**Intel 450KX/GX PCIset
Specification Update
82454KX/GX (PB)
82453KX/GX (MC)
82452KX/GX (DP)
82451KX/GX (MIC)**

Release Date: April 1998

Order Number: 243109-014

3. CMOS Overshoot/Undershoot Specification

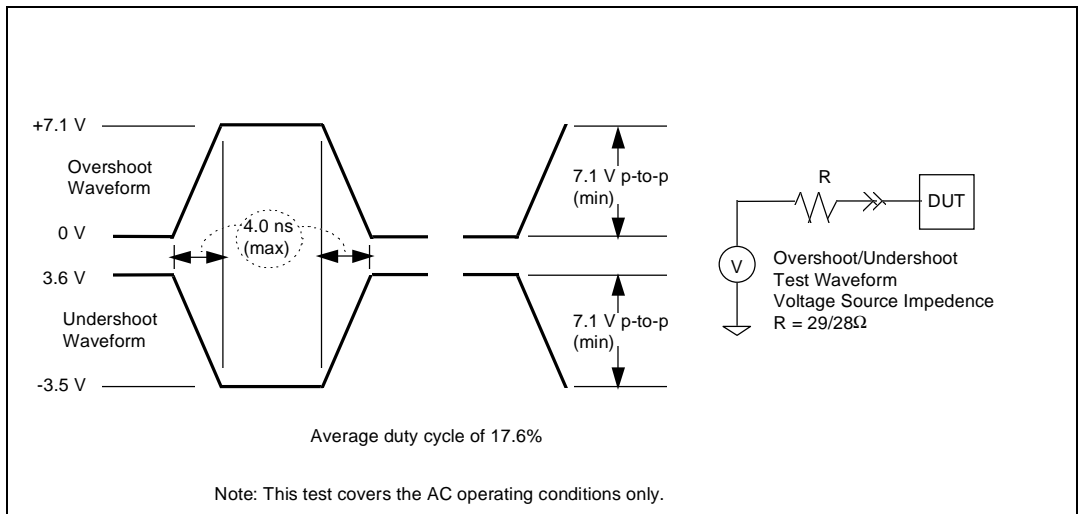
The following will be added to Chapter 4, Section 2.4., "Intel 450KX/GX Undershoot Specification," in the *Intel 450KX/GX PCIsset* datasheet, and the section will be retitled "Intel 450KX/GX Overshoot/Undershoot Specifications."

The 3.3 V tolerant CMOS signals of the processor bus allow for the following maximum AC waveforms:

6. ***Inbound Write Posting May Cause Write Failure***

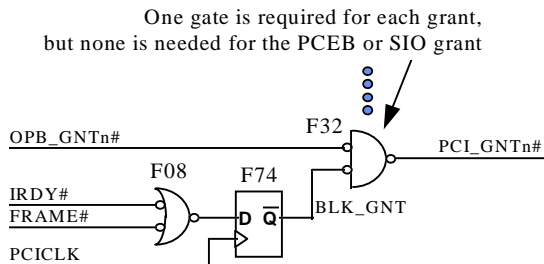
PROBLEM: During an inbound posted write burst, the 82454 PB may use the same data buffer for two adjacent transactions. This causes the first write to use and deallocate the data from the second write, corrupting data

and incorrectly deallocating a data buffer. When the data phase for the second write arrives, DBSY# may be asserted for some time, with no data phase or DRDY# assertion. When the PCI master completes the write burst, the deallocated buffer is never rewritten, resulting in a system hang with DBSY# asserted.

IMPLICATION: Enabling inbound write posting may cause data corruption followed by a system hang. Disabling inbound write posting may result in significant I/O performance loss.

WORKAROUND: An external arbiter should be implemented which allows inbound posting to be enabled, and guarantees at least two idle cycles between inbound PCI requests.

This arbiter must not perform overlapped arbitration. One way to ensure this is to implement the circuit described below, external to the arbiter. The actual workaround involves waiting for a bus idle before allowing a new grant to be issued. The IOQ depth must still be set to 1, and 2:1 interleaving must be used, to work around other errata which may surface when inbound write posting is enabled (even with this workaround). Note that this latter restriction requires at least 4 SIMM DRAM modules to be loaded at all times.

This following circuit is an implementation of the described workaround:

This workaround will allow inbound write posting to be enabled on A2 450KX PCISet silicon, and will not affect the functionality of B0 450KX/GX PCISet silicon, though a slight performance loss may result if this workaround is used with the B0 stepping. Enabling inbound posting by using this workaround is a significant performance enhancement for systems with A2 450KX PCISet silicon; refer to Intel's World Wide Web site for more details on the performance loss incurred by disabling inbound write posting (at URL <http://www.intel.com/procs/support/ppro/82450.htm>).

Figure 1. V_{CC} Increase vs. T_{CASE} Drop for DPLL Failure (Worst Case)

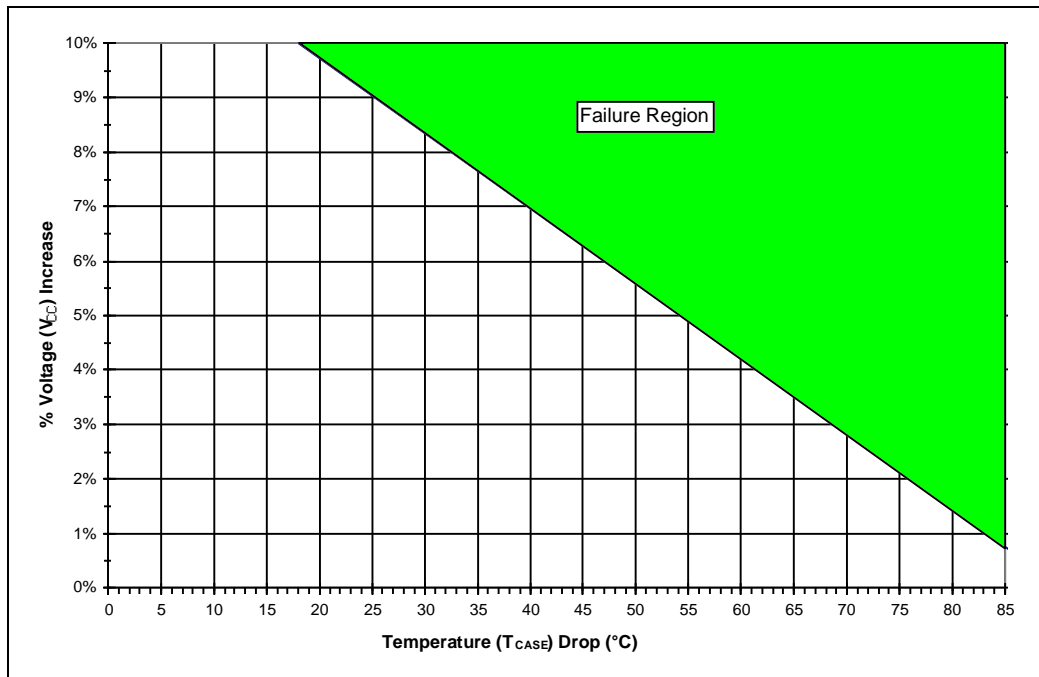
The current specification states that the Intel 450KX/ PCISset is operational over a T_{CASE} range of 0 - 85 °C and a V_{CC} range of 3.3 V ± 5%.

After a device has undergone a hard reset of the DPLL (via the PLLRST pin), a drop in T_{CASE} accompanied by an increase in V_{CC} may cause this erratum to occur. The magnitude of the temperature drop and supply voltage increase required to cause this failure is graphed below:

IMPLICATION: If the T_{CASE} of any Intel 450KX PCIsset component is allowed to decrease by more than 18 °C after the point at which DPLL lock is obtained after a DPLL hard reset, a positive voltage swing may cause the component to lose its internal clock for 2 - 500 processor bus clocks. This may result in a system hang, lost data, or other unpredictable system failure (note that if the component is not processing commands or data for the time during which the internal clock is lost, no failure will be observed). The larger the temperature drop and/or voltage swing, the more likely the failure.

3. CMOS Overshoot/Undershoot Specification

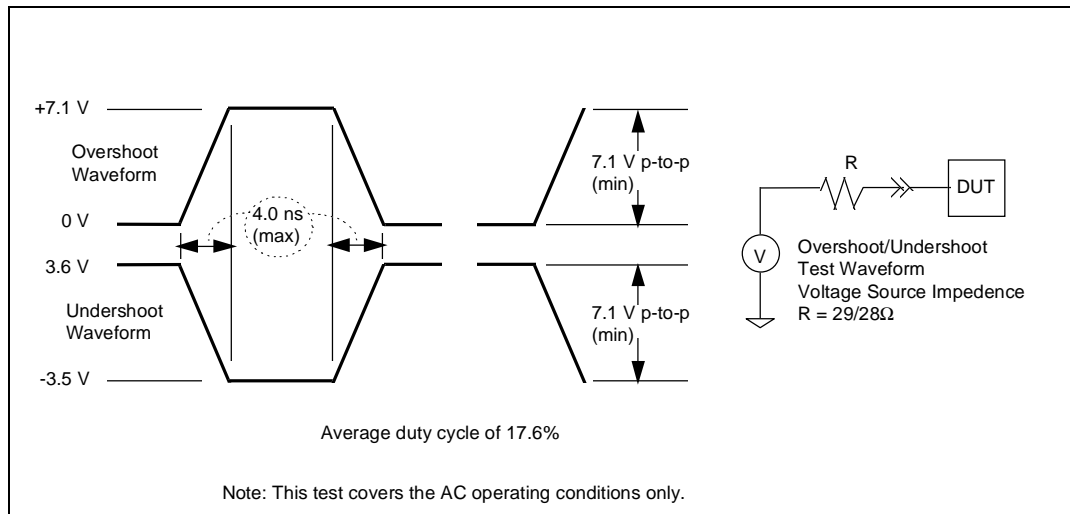
The following will be added to Chapter 4, Section 2.4., "Intel 450KX/GX Undershoot Specification," in the *Intel 450KX/GX PCISSET* datasheet, and the section will be retitled "Intel 450KX/GX Overshoot/Undershoot Specifications."

The 3.3 V tolerant CMOS signals of the processor bus allow for the following maximum AC waveforms:

Figure 1. V_{CC} Increase vs. T_{CASE} Drop for DPLL Failure (Worst Case)

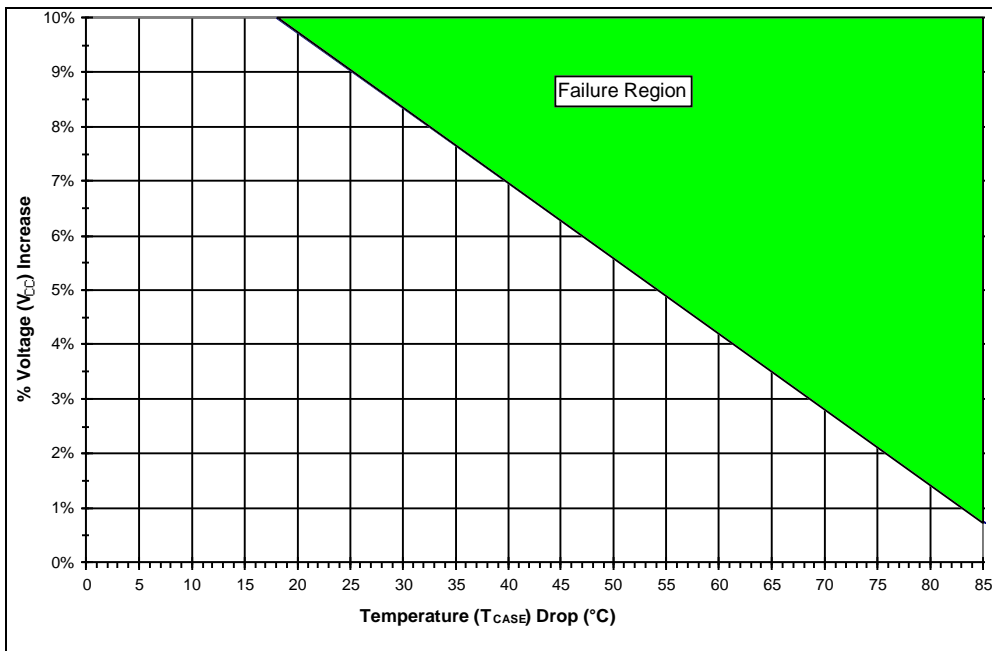
The current specification states that the Intel 450GX PCISSET is operational over a T_{CASE} range of 0 - 85 °C and a V_{CC} range of 3.3 V ± 5%.

After a device has undergone a hard reset of the DPLL (via the PLLRST pin), a drop in T_{CASE} accompanied by an increase in V_{CC} may cause this erratum to occur. The magnitude of the temperature drop and supply voltage increase required to cause this failure is graphed below:

IMPLICATION: If the T_{CASE} of any Intel 450GX PCIset component is allowed to decrease by more than 18 °C after the point at which DPLL lock is obtained after a DPLL hard reset, a positive voltage swing may cause the component to lose its internal clock for 2 - 500 processor bus clocks. This may result in a system hang, lost data, or other unpredictable system failure (note that if the component is not processing commands or data for the time during which the internal clock is lost, no failure will be observed). The larger the temperature drop and/or voltage swing, the more likely the failure.
